Landscape Review Committee
Community Development Center, 231 NE 5th Street
October 17, 2018
12:00 PM

DATE: October 17, 2018
TO: McMinnville Landscape Review Committee
FROM: Jamie Fleckenstein, Associate Planner
SUBJECT: Agenda Item 4A: L 13-18

An application for a landscape plan for the renovation of an existing single family home into commercial space (L 13-18) to be reviewed by the Landscape Review Committee.

DECISION, CONDITIONS OF APPROVAL, FINDINGS OF FACT, AND CONCLUSIONARY FINDINGS OF THE MCMINNVILLE LANDSCAPE REVIEW COMMITTEE FOR APPROVAL OF LANDSCAPE PLAN FOR THE RENOVATION OF A SINGLE FAMILY HOME INTO COMMERCIAL SPACE AT 435 NE JOHNSON STREET

ORIGINAL LANDSCAPE PLAN

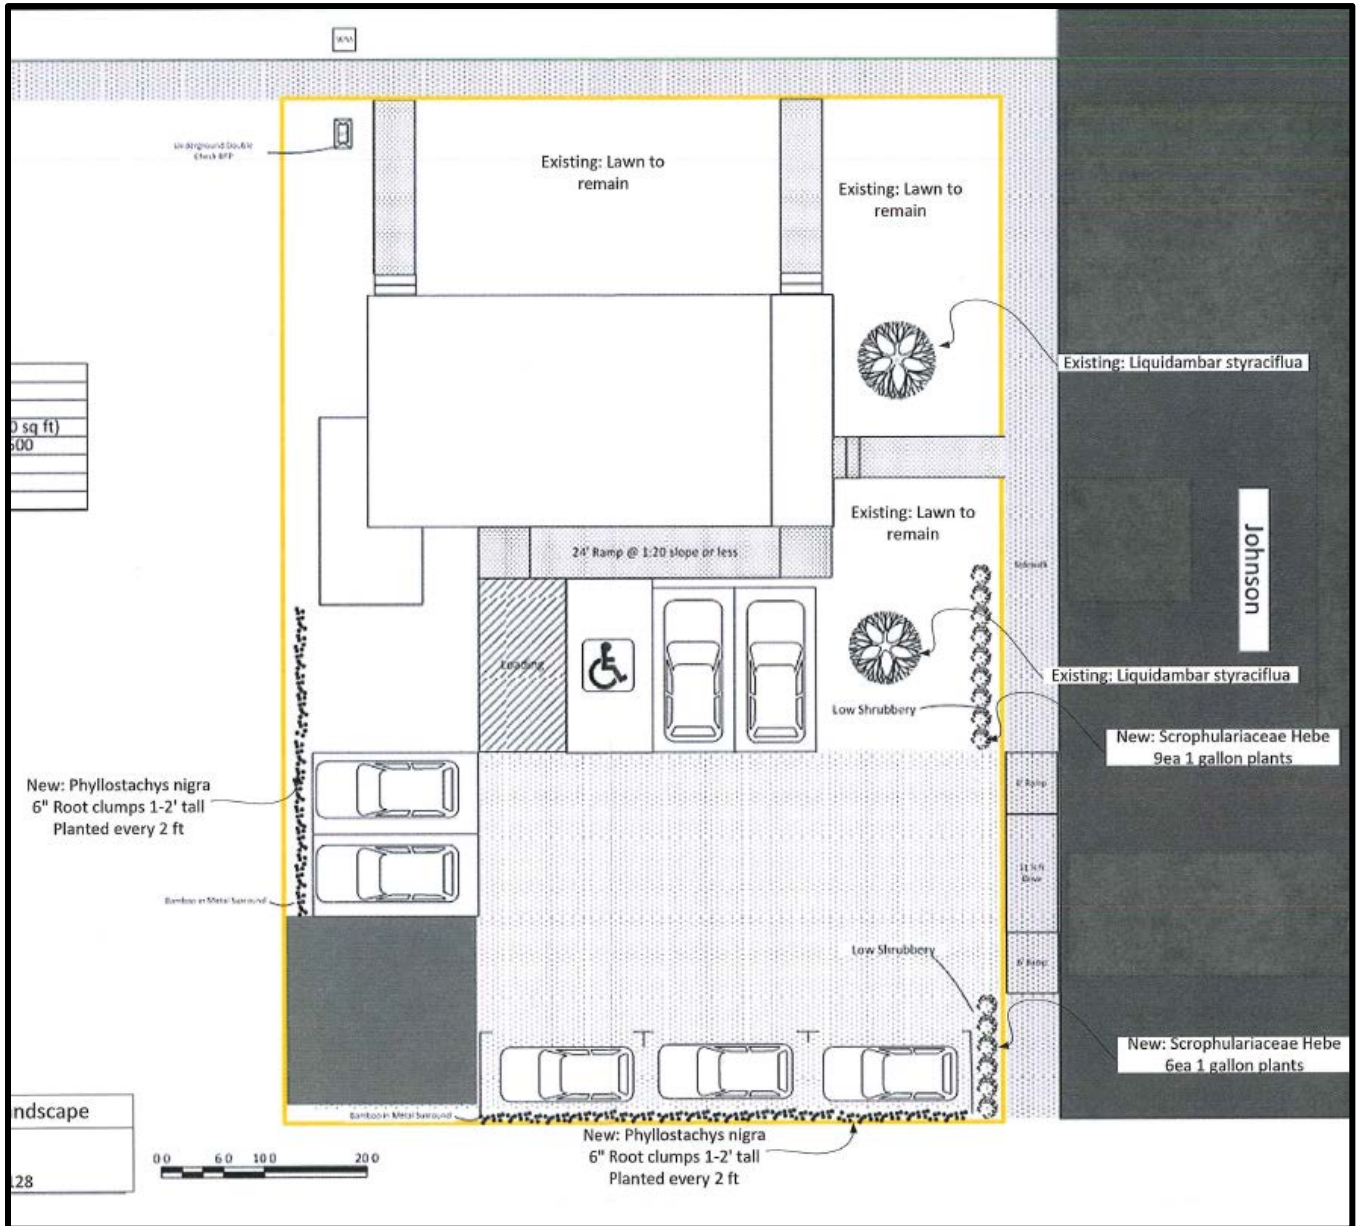
The Landscape Review Committee reviewed the original application and plans at their June 20, 2018 regular meeting. At that meeting the Committee decided to continue the application to allow the applicant to make revisions to the plan to address bamboo root containment and other plant material selection around the parking lot.

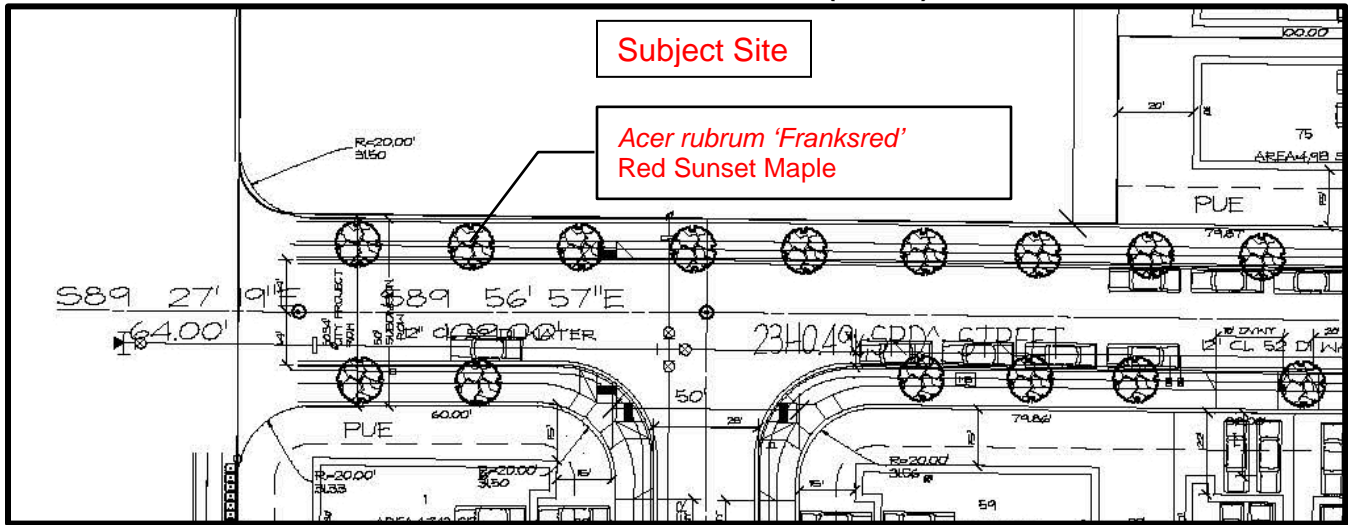
Armstrong Red Maple is a deciduous tree that grows to a height of 50 to 70 feet tall, and 15 feet wide. Bark on the tree is silver grey, and the foliage's fall color is an erratic yellow-orange. The spacing of the trees within the parking lot is between 40 and 60 on center. At maturity at this spacing, the narrow, upright Armstrong Red Maple would not provide continuous canopy.

BAKER CREEK WEST STREET TREE PLAN – HILL ROAD

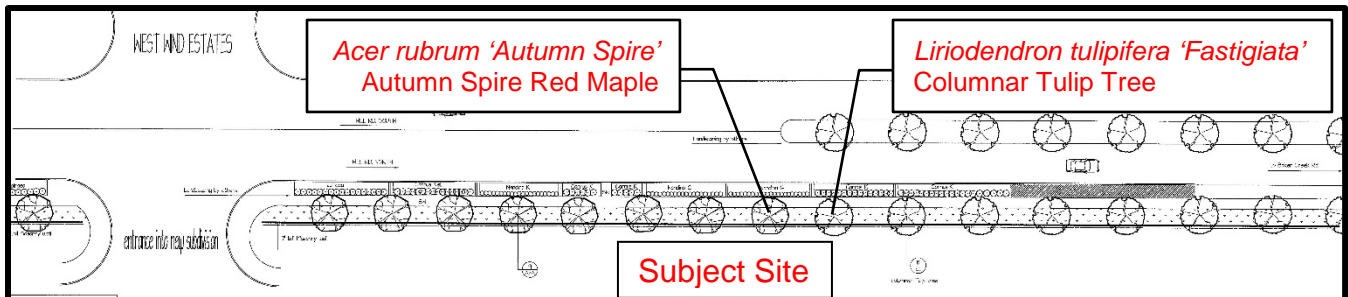
The street trees along 23rd Street are spaced at approximately 30 feet on center, and the street trees along Hill Road are spaced at about 35 feet on center. Because these street trees are not shown on the proposed landscape plan, it is not clear what the spacing is between the approved street trees and proposed trees. Staff recommends a condition of approval that no tree shall be spaced closer than 20 feet to a street tree in the Hill Road right-of-way, and no tree shall be spaced closer than 20 feet to a street tree on 23rd Street.

BAKER CREEK APARTMENTS IRRIGATION PLAN – NORTH ENLARGEMENT

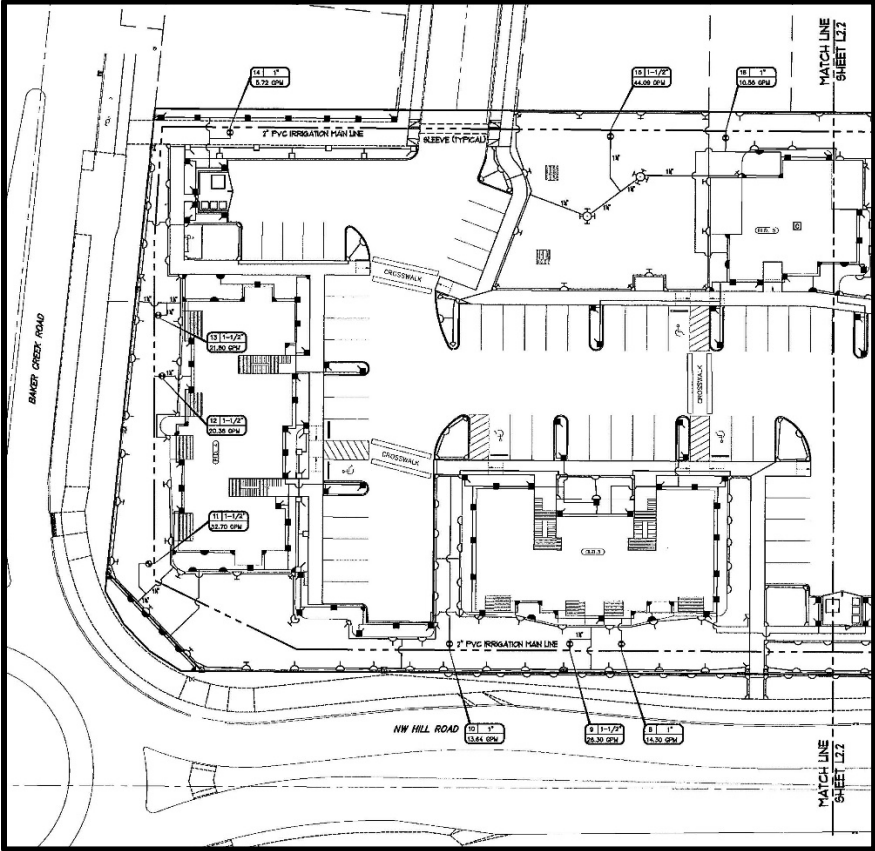
An irrigation plan was submitted as part of the proposed landscape plan, and can be seen below. The irrigation plan indicates a full automatic irrigation system is to be installed in or near the planting areas.

Tree #5: Exhibits old wounds from limb breakage

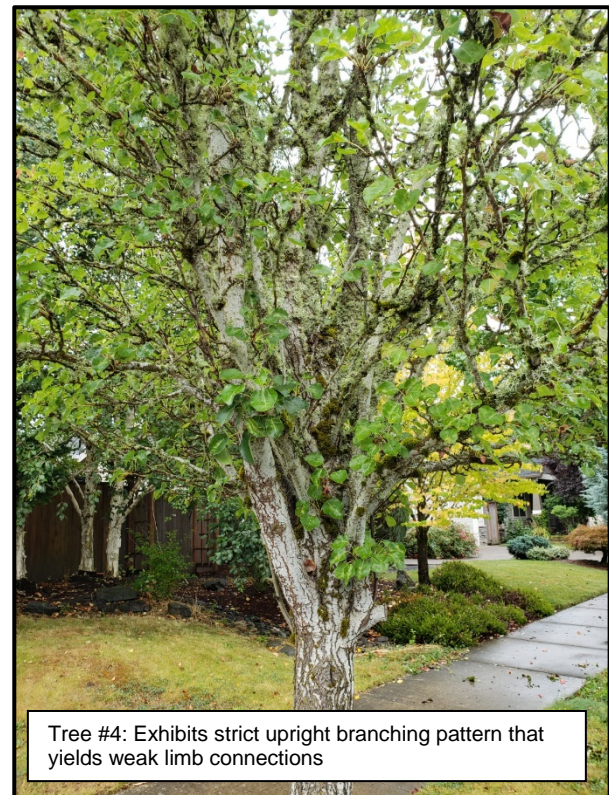
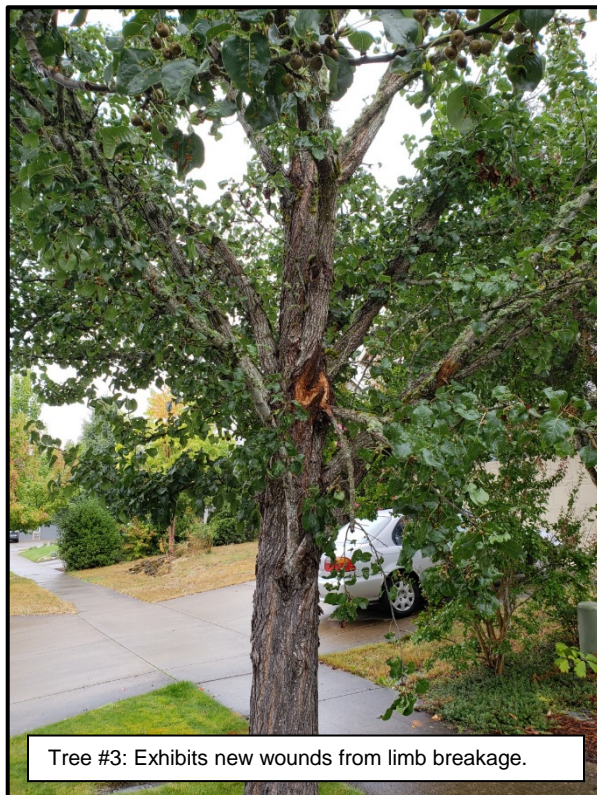
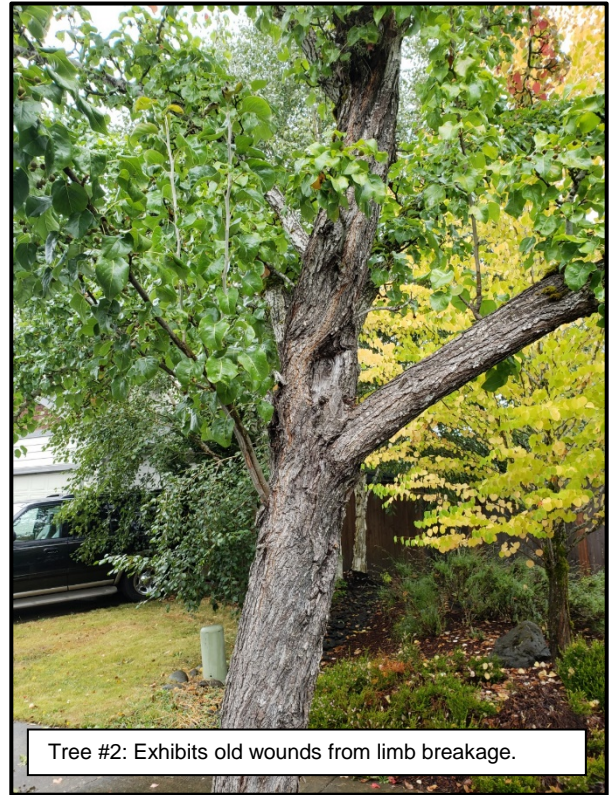
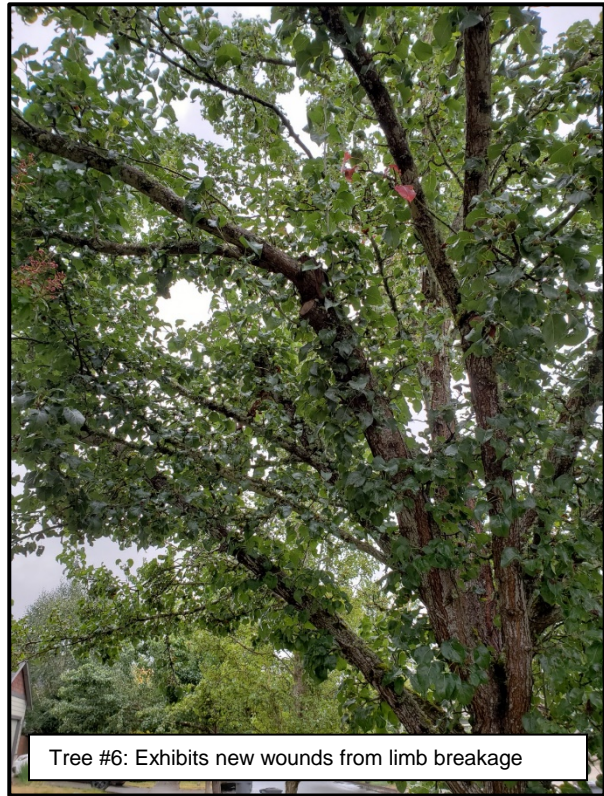
To provide further information to the Planning Director for consideration of the emergency tree removal permit request, staff conducted a visual inspection of the street trees requested to be removed in front of 1746 NW Jacie Way, as well as the other *Pyrus calleryana* 'Chanticleer' trees along the street. Approximately 80% of the Chanticleer Pear street trees on Jacie Way show evidence of large limb breakage, including recent scars, old scars, and recent broken limbs. All the trees show the branching structure characteristic of the variety that leads to weak connections and limb failure – distinctly upright branching patterns causing with narrowly crotched branches with included bark. This leads staff to

believe that these street trees will continue to exhibit limb failure and breakage as the trees age. Representative photos of the *Pyrus calleryana* 'Chanticleer' trees along NW Jacie Way are seen below:
